Dwight D. Eisenhower Memorial Modification

United States Department of the Interior, National Park Service on behalf of the Dwight D. Eisenhower Memorial Commission

Revised Concept Design

February 2, 2017

1. Tapestry

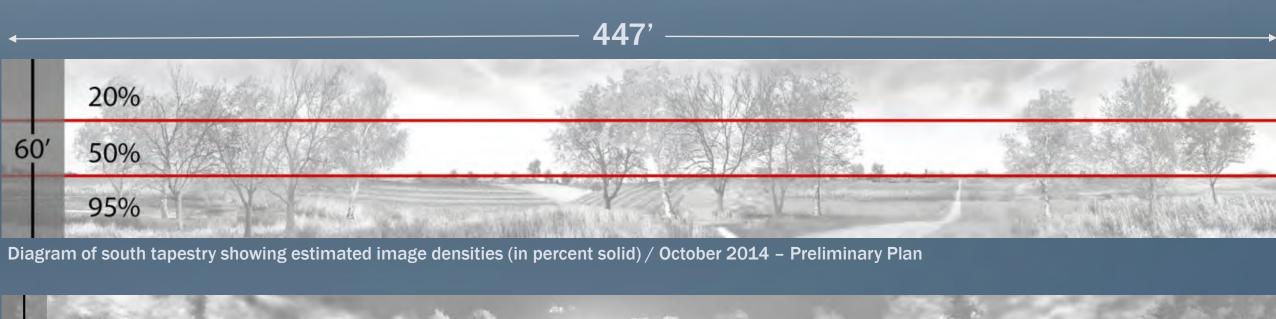
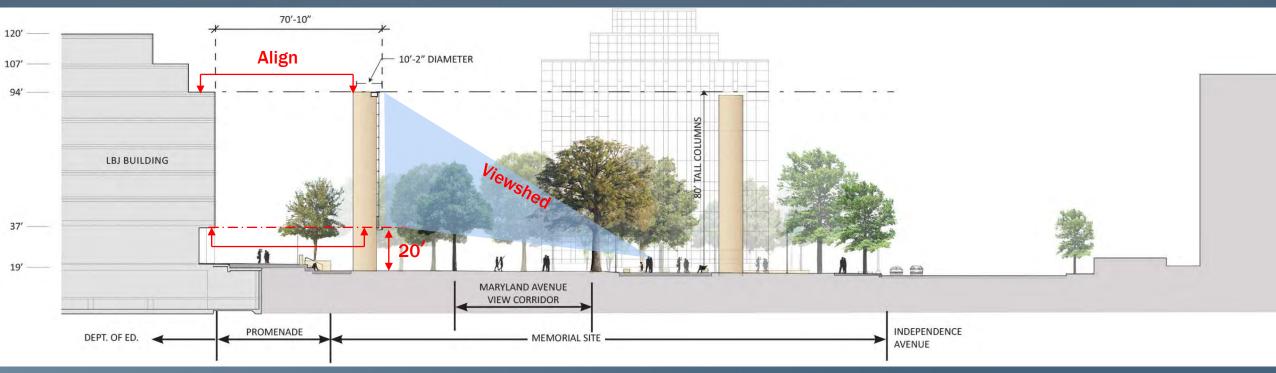
Requests additional visual studies and a mock-up of the revised tapestry that address any impacts to the Lyndon B. Johnson Department of Education Headquarters including views of the building through the tapestry, the memorial itself, and surrounding context.

3. Memorial Core - Young Eisenhower Statue

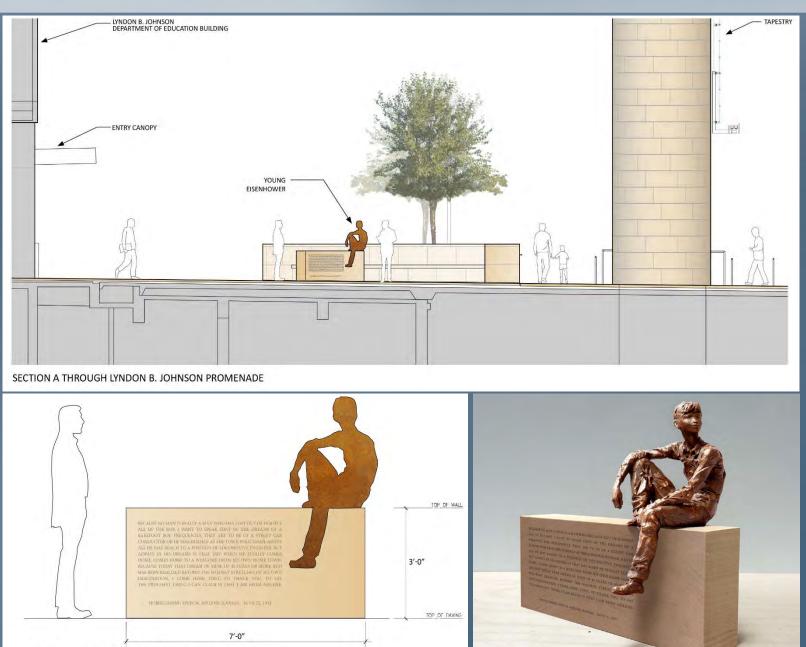
Requests a revised lighting plan consistent with the overall lighting design for the memorial that considers the relocated young Eisenhower sculpture and its associated inscription wall.
